Title of Change:	NCV68261 - Product robustification
Effective date:	20 Mar 2023
Contact information:	Contact your local onsemi Sales Office or Juraj.Kremmer@onsemi.com
Type of notification:	This Product Bulletin is for notification purposes only. onsemi will proceed with implementation of this change upon publication of this Product Bulletin.
Change Category:	Wafer Fab Change
Change Sub-Category(s):	New masks to increase passivation to pad metal overlap

Representative picture of the passivation to pad metal overlap increase:

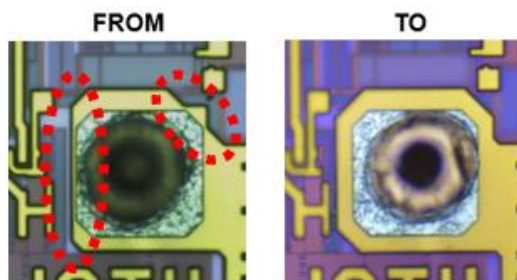
This is a product robustness improvement. In order to make the product more robust against potential issues, the passivation to pad metal overlap has been increased from minimum 2.12 um to minimum 6 um. The change is in the passivation to pad metal overlap only, done by increasing the pad metal dimensions.
 No change to the bond pad opening dimensions.
 No change in the pad composition and pad metal thickness.

From	To
Minimum passivation to pad metal overlap	2.12um	6um
